HV Bias Power Patch Panel for Scintillator KLM

2015-07-16

- overview
- Schematics
- layout
- Parts

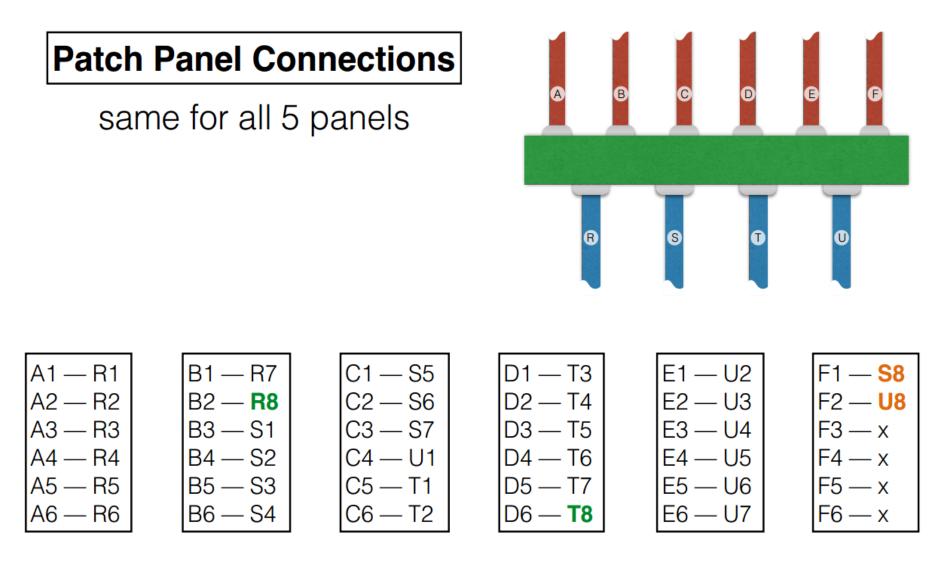
R8 and T8 are spare channels for EKLM, assigned channels for BKLM.
 S8 and U8 are not used for EKLM [no F], assigned channels for BKLM.
 F3, F4, F4 and F6 are not used – *is there any way to make these spares?*

Chris's email

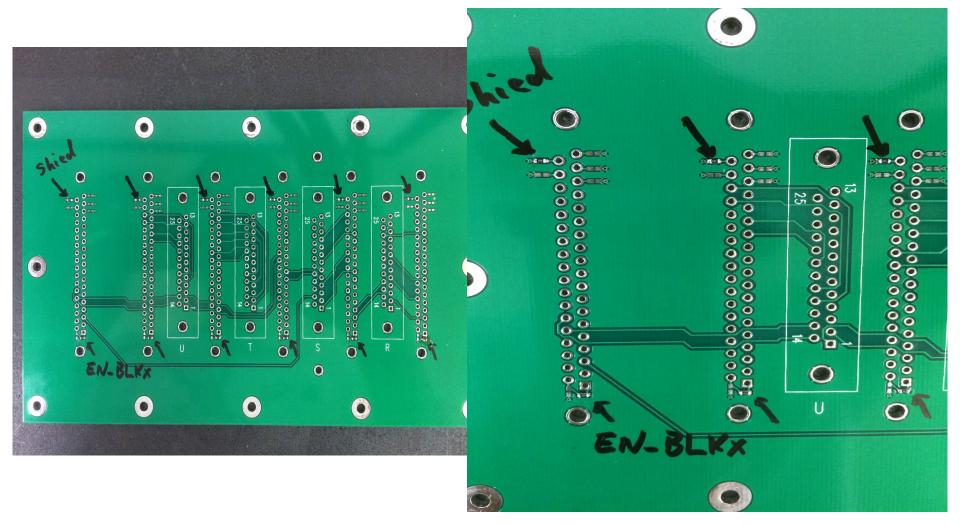
Here is a preliminary idea for the patch panel support. (You must download file and open through Adobe to get 3D to work.) I have a few suggestions I would like to make, then, pending your agreement,

- I will be ready to share model with others for comments.
- 1. Holes are not symmetric with respect to board outline.
- 2. Adding 2 more mounting holes would make this much tougher.
- 3. If board was bigger, say 4.5 x 7 inches, then I could make the cutouts in the patch panel bigger and have more room for connectors to plug in.

Finished hole size of 134 mil will allow manufacturer to use a #29 drill bit (136 mil). This will give 16 mils of play around the bolt, which is regarded as a "loose fit."
